CIMARRON HILLS PHASE 2 MULTI-FAMILY

SITE DEVELOPMENT PLAN AND PHALPLAT CEPTER OF INTENT

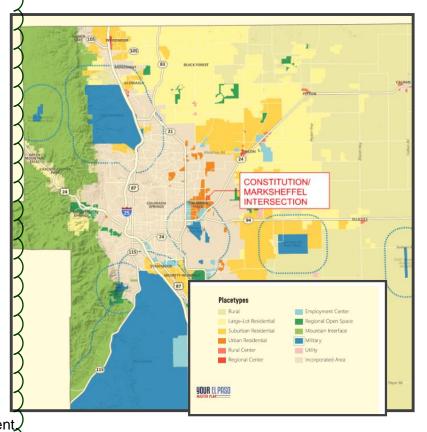
This Master Plan analysis should also include analysis of the key area and area of change

This is an Employment Center placetype. Residential uses are not recommended in employment centers - the zoning is nonconforming to the placetype.

Land Use

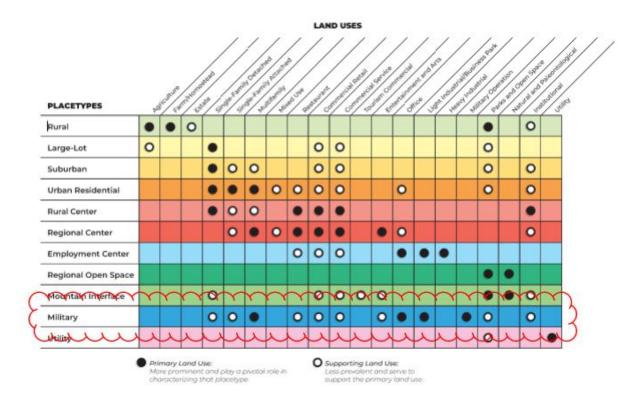
This is not correct. The property is not within the military placetype. It is within the military reservation buffer, so the military placetype can influence the development of the property. Important to make this distinction - you can use the military placetype to help justify, but be clear that it is not located within it.

Please provide more detail here. There is no other residential uses within the airport overlay in this area. Residential uses nearby are only acceptable because they are outside the ADNL and APZ sub-zones

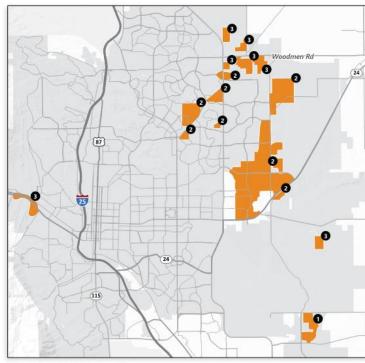
This is not correct.
This property is located within an Employment Center priority development area, which this development is not consistent with.

Replace this section with an analysis of the employment center priority area that this property is located in.
